UNITED STATES PATENT AND TRADEMARK OFFICE

Office Action Summary	Application No.	Applicant(s)	
	10/691,746	SHUR ET AL.	
	Examiner	Art Unit	
	PHILLIP A. JOHNSTON	2881

Detailed Action

FIG. 6

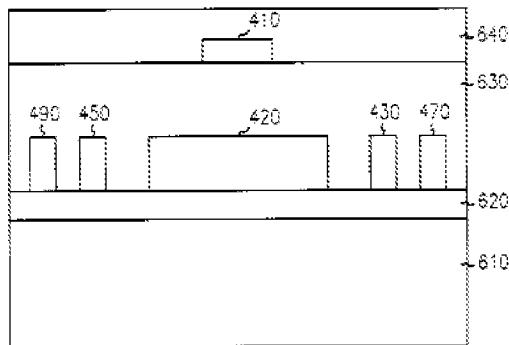
Bowes discloses at Col. 11, line 62-67; and Col. 12, line 1-13, an overlay measurement mark having a box-in-box structure with a first layer 640 including feature 410 and a second layer 630 with plural features located below the first layer, some of which are not overlapping (430, 450 etc.) as shown in Figure 6 below. Bowes also discloses at Col. 12, line 6-13, that the overlay mark structure includes additional intermediary layers.

Bowes modifies the combination of Essers and Chen to provide a layered mark for measuring layer misalignment induced by process fabrication steps and for estimating overlay errors. [0012] and 0053].
